SERVICE BULLETIN

REWORK OF HORIZONTAL STABILIZER ASSEMBLY (P/N 421-087-503 AND -505).

All McDonnell Douglas Helicopter Company (MDHC) 369E and 369F/FF Series helicopters.

Figure 1. Horizontal Stabilizer Rework.

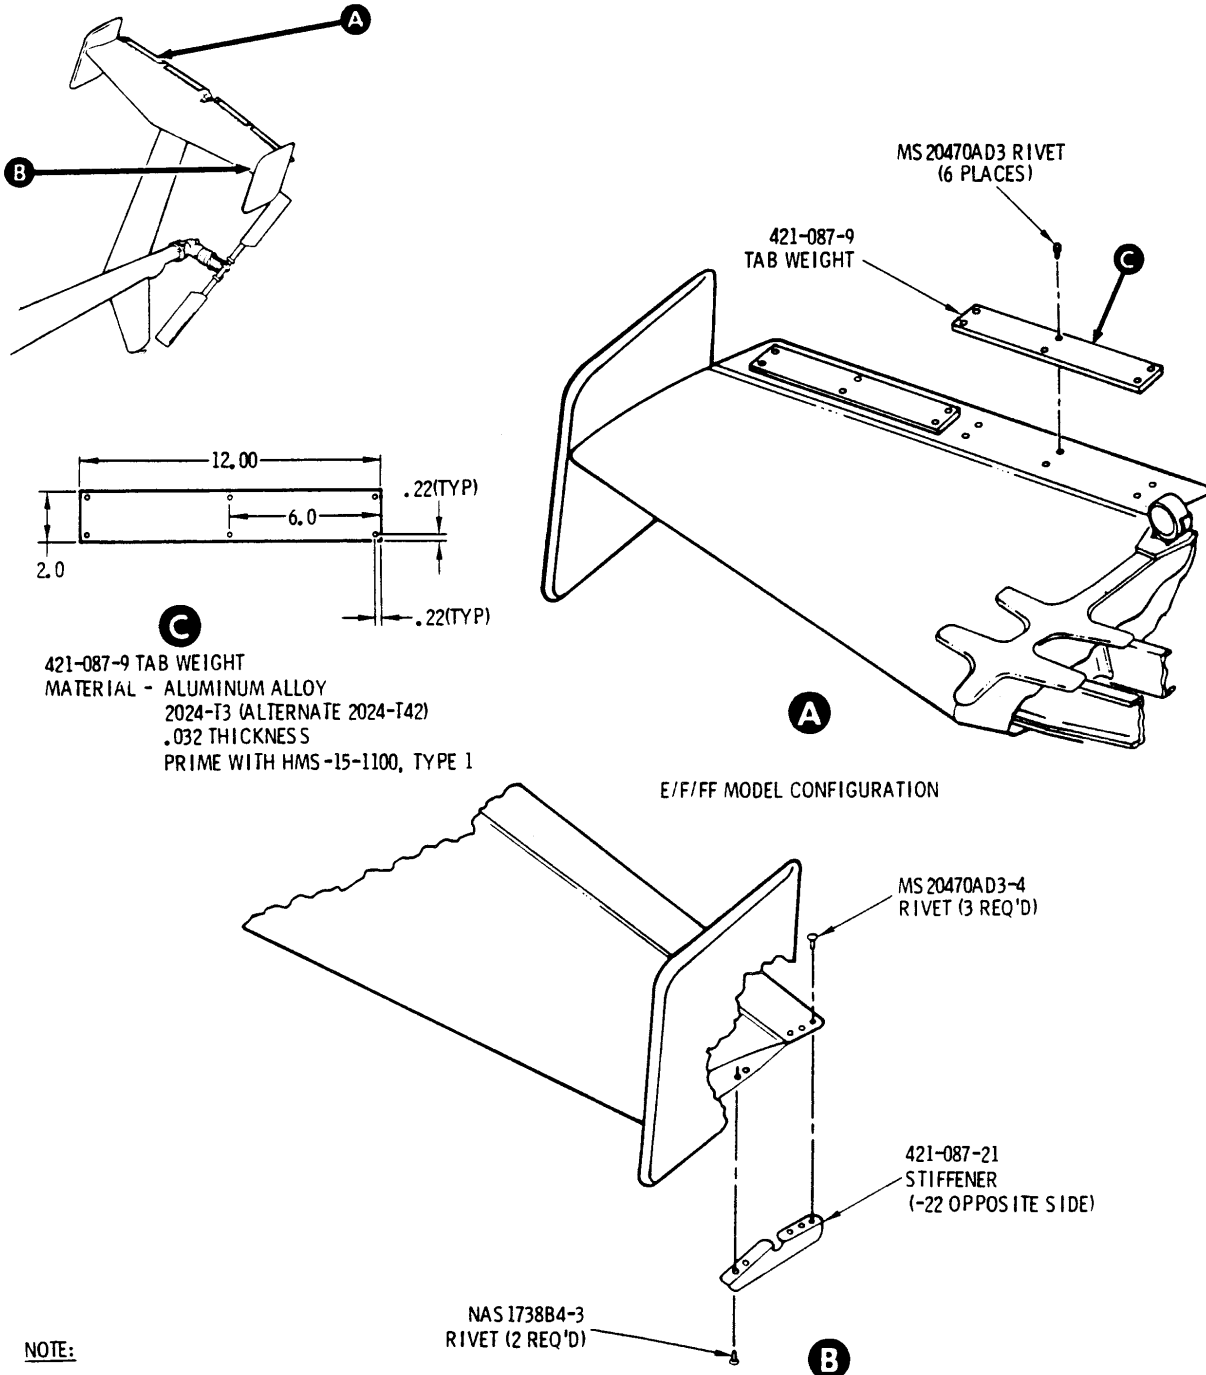
MDHC has received reports of the horizontal stabilizer skin and tabs cracking as a result of a vibration at the outboard ends of the horizontal stabilizer tabs. Therefore, MDHC is requiring operators to perform the following rework of the horizontal stabilizer assembly.

- b. Install stiffeners on outboard ends of horizontal stabilizer as shown in Figure 1 and the following instructions:
 1. Drill out existing NAS1738B4-3 rivets as shown in Figure 1 using #27 size drill bit.

2. Position stiffeners as shown in Fig. 1 and drill remaining holes using #40 size drill bit.
 3. Apply zinc-chromate primer to holes.
 4. Install NAS1738B4-3 and MS20470AD3-4 rivets per Figure 1.

- f. If tab resonance occurs and tail rotor balancing is unacceptable, fabricate, apply primer to non-bonding surfaces and install (2) 421-087-9 tab weights adjacent and immediately inboard from the existing tab weights (if installed, see the following note) per the following instructions and as shown in Figure 1.

- If tab resonance is not evident and the tabs weights are not installed, proceed to Step h.
 - If the outboard tab weights have been previously removed, install weights in the outboard locations as shown in Figure 1. If required, a maximum of two sets of tab weights may be installed to eliminate tab resonance.

1. Clean all tab weight and horizontal stabilizer bonding surfaces down to the primer in the area to be bonded.
 2. Apply adhesive to tab weights and horizontal stabilizer and position tab weights as shown in Figure 1. Fair in edges with adhesive squeeze out.

3. Install rivets in the same pattern as existing tab weights prior to adhesive curing. Allow adhesive to cure and touch up finish to match adjacent area.

421-087-9 TAB WEIGHT
MATERIAL - ALUMINUM ALLOY
2024-T3 (ALTERNATE 2024-T42)
.032 THICKNESS
PRIME WITH HMS-15-1100, TYPE 1
